Status & Remarks

35 U.S.C. §112

FIG-3

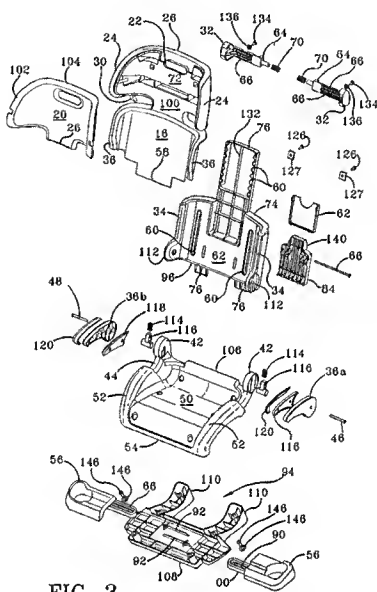
least two releasable means for securing said movable component in either said retracted or said at least one extended position.” The Office has assumed that this recited upwardly-extending projection corresponds to the disclosed projection 64.

The applicant’s attorney regrets the confusion which apparently was caused to the Office, and has amended the claim to remove this confusion. The applicant’s attorney intended that the “upwardly-extending projection” correspond to the component labeled 78 in Fig. 3.

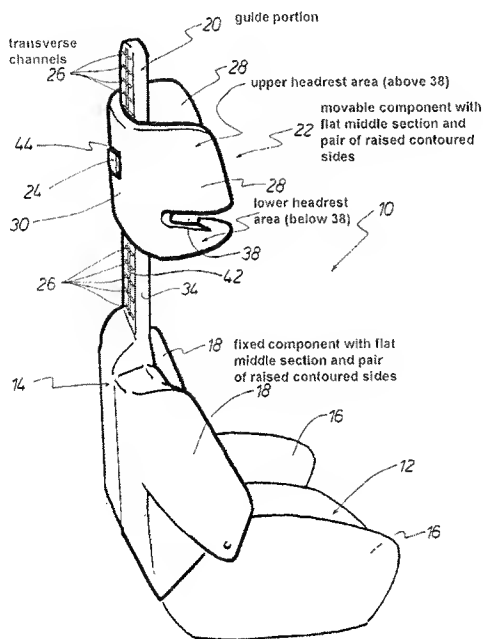
It is not understood how the examiner can conclude that there is "*a surface and contour of the lower area in cross-section for sliding movement along a mating contoured surface in cross-section of the fixed component*" in that there is no sliding whatsoever between the two components.

Additionally, there does not appear to be any teaching which shows "*movement from the retracted position to the extending position occurring by sliding movement of the moveable component over the fixed component along the raised contoured sides of both the fixed and movable components*" in that there is no sliding over any contours.

One of the keys to the applicant's invention is the fact that there is no "gap" between the fixed and movable components. When the *Reithmeier* car seat is in its extended position as illustrated to the left, there is without question, a gap between the fixed and movable component, a feature which is highly undesirable whether the gap is in the pelvis area (as illustrated by *Lovie* discussed below, or in the shoulder area (as illustrated by *Reithmeier*). There is no corresponding teaching to "*the fixed and movable components in an overlapping essentially gapless relationship*" as there most assuredly is a gap in *Reithmeier*.

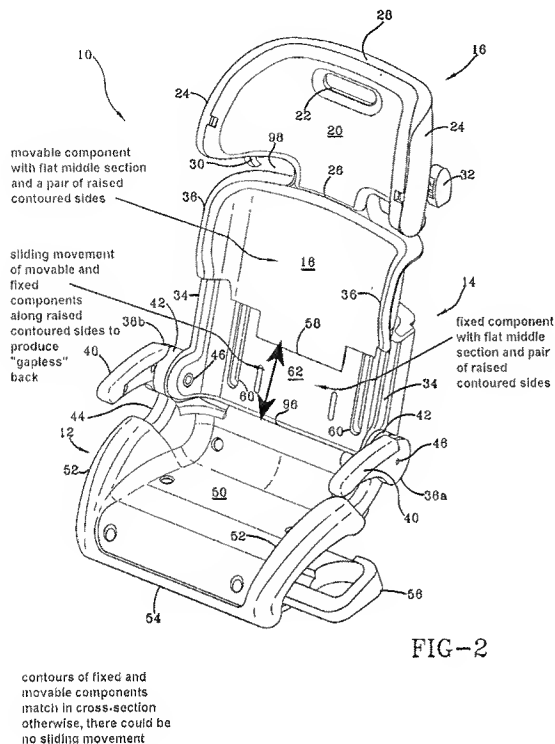
art identified by the examiner, or which the applicant and/or his attorney is aware of. For purposes of illustration, the applicant's attorney has focused on these distinctions in the annotated graphic below.

In the applicant's invention, it is correct to state that there is "a surface and contour of the lower area in cross-section for sliding movement along a mating contoured surface in cross-section of the fixed component."

In the applicant's invention, it is correct to state that there is "movement from the retracted position to the extending position occurring by sliding movement of the moveable component over the fixed component along the raised contoured sides of both the fixed and movable components."

In the applicant's invention, it is correct to state that there is no "gap" between the fixed and movable components and therefore, "the fixed and movable components [are] in an overlapping essentially gapless relationship".

Meeker & Gibson invention

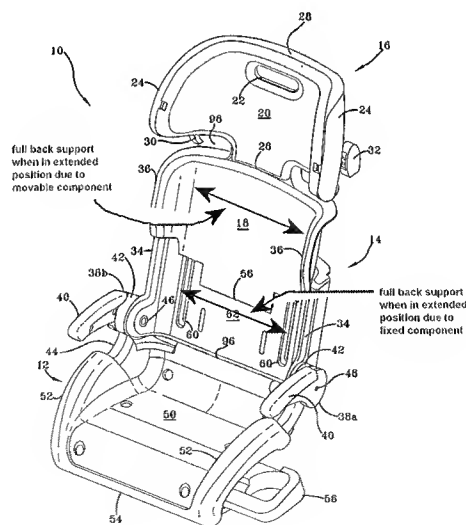
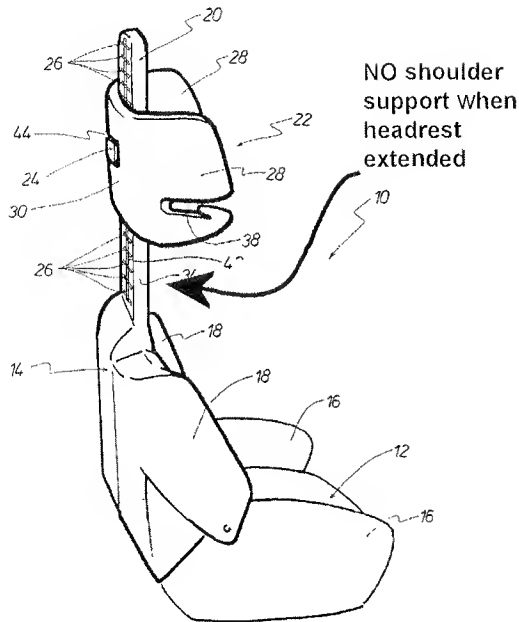
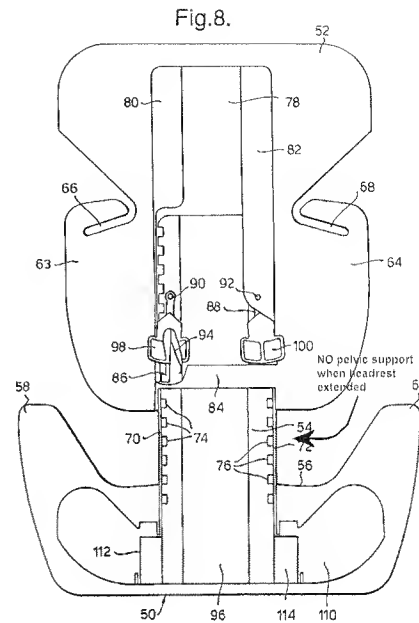
No reference which the examiner has identified has this combination, the value of which is that the occupant has complete back support both in the pelvis area (thereby overcoming a shortcoming of *Lovie*) and in the neck region (thereby overcoming a shortcoming of *Reithmeier*) as illustrated below. This is an unobvious improvement over the prior art, and certainly not within the teachings of either *Reithmeier* and/or *Lovie* taken individually or in combination.

Traditional logic would have employed a center rail arrangement as taught by *Reithmeier* and *Lovie*, thereby leaving the occupant exposed in either the pelvis area or in the shoulder area, both of which are undesirable configurations in a rear-end collision. The *Meeker & Gibson* invention overcomes the limitations of the prior art in a manner which is reflected in the claims.
